SUMMARY OF TENT REQUIREMENTS FOR EGRESS COURT
 (From Dec. 7, 2015 Meeting - Refer to Complete Minutes for Additional Information)

A PROPOSED PLAN - ARNOLD PLAZA - PROPOSED EGRESS (W/30'X45" TEMPORARY TENT)
 Scale: 1" = 10'-0"

**GREATER COLUMBUS CONVENTION CENTER
 ARNOLD PLAZA - EGRESS REVIEW**

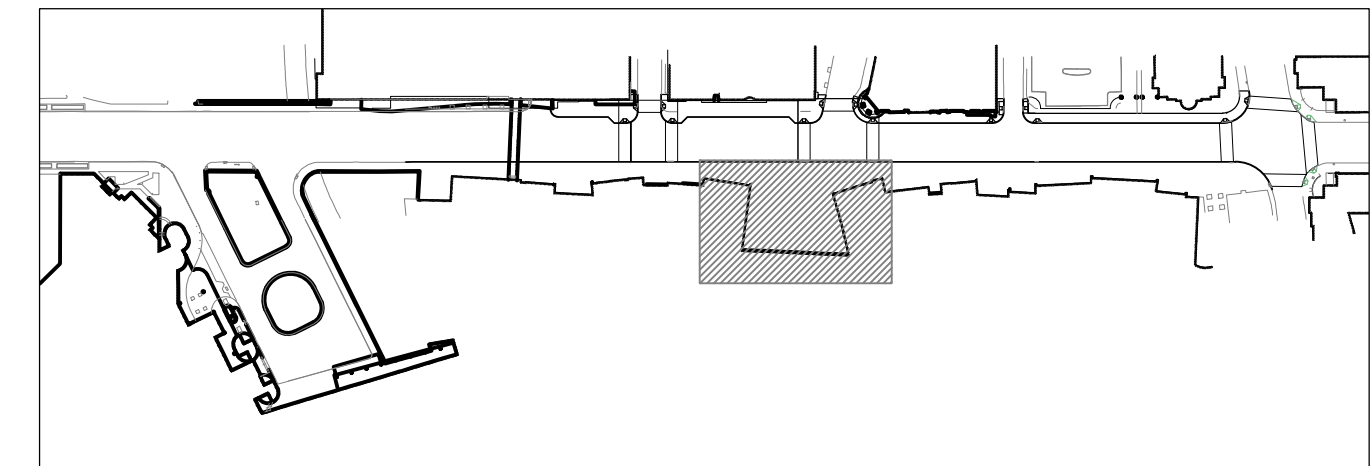
- Fire Code and Building Code require tents to have 12' separation from a building or from other tents.
 - This is a clear dimension free of any obstructions such as guy ropes, plant beds, raised walls, etc.

- The tent needs to be open on the sides parallel to egress doors (path of egress) with no flaps or walls. This will facilitate egress from the exit doors through the court.

- Flaps or walls parallel to the direction of egress are permitted since this would not inhibit egress.
- The tent occupancy will not need to be added to the building occupancy as the tent will egress first.

- The tent will need to have a 7' clear height underneath to facilitate egress through the tent.
- Davits or tie downs will need to be flush with the paving surface so there are no trip hazards when the tent is not in place.

- A tent permit will be required to install a tent in the court if the tent exceeds 700 SF in area per exception #2 of OBC section 3103.1.2. The tent permit can be expedited if the GCCC decides to purchase the tent structure and the structure meets all the requirements of the egress court and section 3103.

NOTE**
 Based upon prior review by Columbus-Chief Building Official and Columbus-Division of Fire, the required egress width through the Arnold Plaza (egress court) is 53-feet, 9-inches. This is based on 20 of the 22 doors facilitating egress for meeting rooms and cafe at a fully open width of 32.25".

- 30'x45' tent (1,350 sq. ft.) to be used for temporary events only.
- Anchor covers to be flush with adjacent pavement when not in use.
- 12' clear dimensions shown are from anchors (approximately 1'-0" outside footprint of frame tent).
- No side walls to be installed along 45' long sides to provide egress through tent in the event of an emergency.
- Tent Clear Height to be 8'-0"

The proposed plan provides 55'-3".
